Date of Issue: August 25, 2010

Affected Publication: API Specification 7K, *Drilling and Well Servicing Equipment*, Fifth Edition, June 2010

ERRATA

Figure 11—Rotary Vibrator and Drilling Hose Dimensions

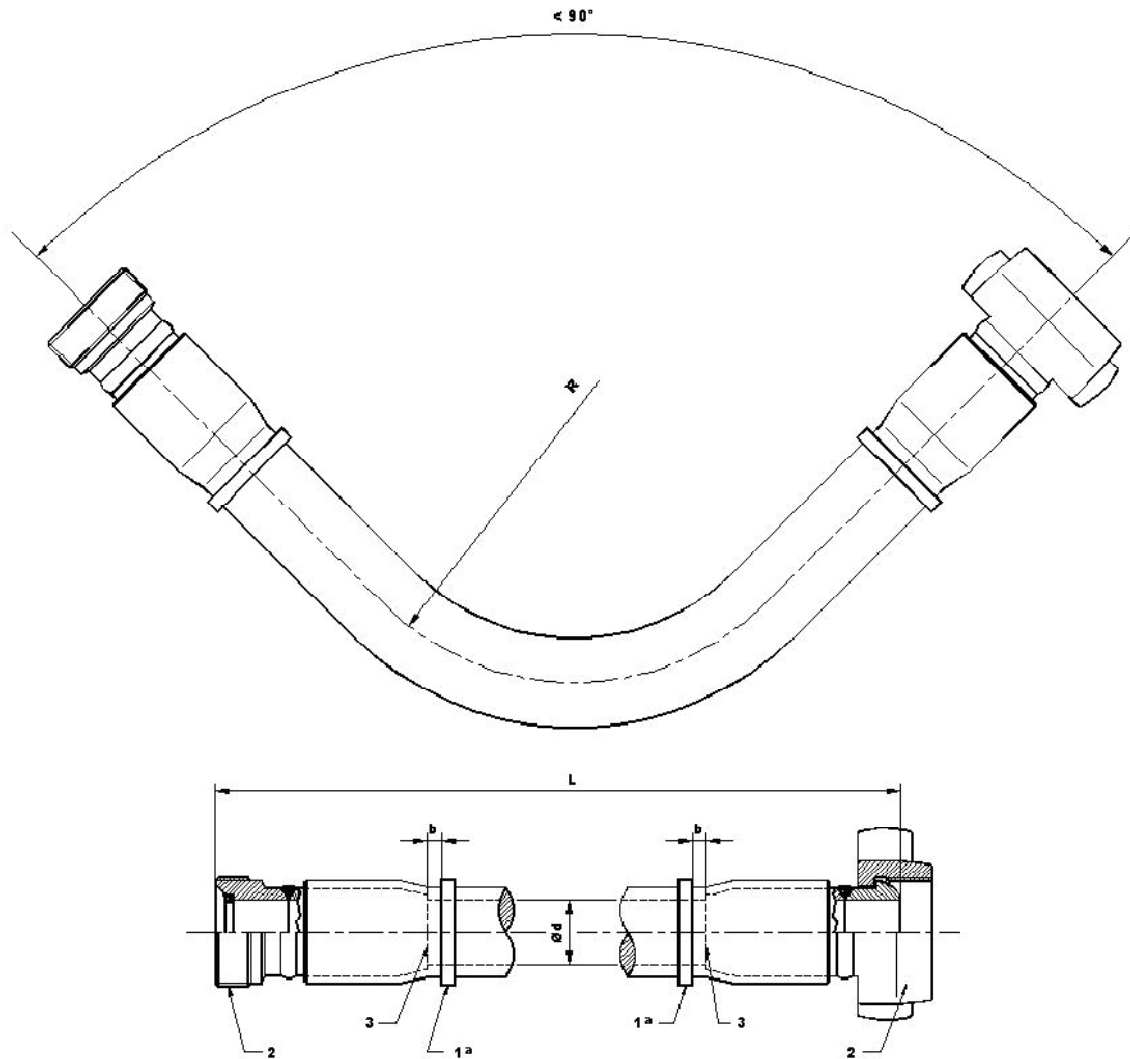
Page 38, Figure 11; replace the existing figure with the following:

- ^a Hose manufacturers shall mark the hose with the notation "Attach Safety Clamp Here."
- ^b For rotary drilling hose, this dimension shall be 150 mm (6 in.) to 460 mm (18 in.) from the inboard end of the coupling. For vibrator hose, this dimension shall be 150 mm (6 in.) to 250 mm (10 in.) from the inboard end of the coupling.
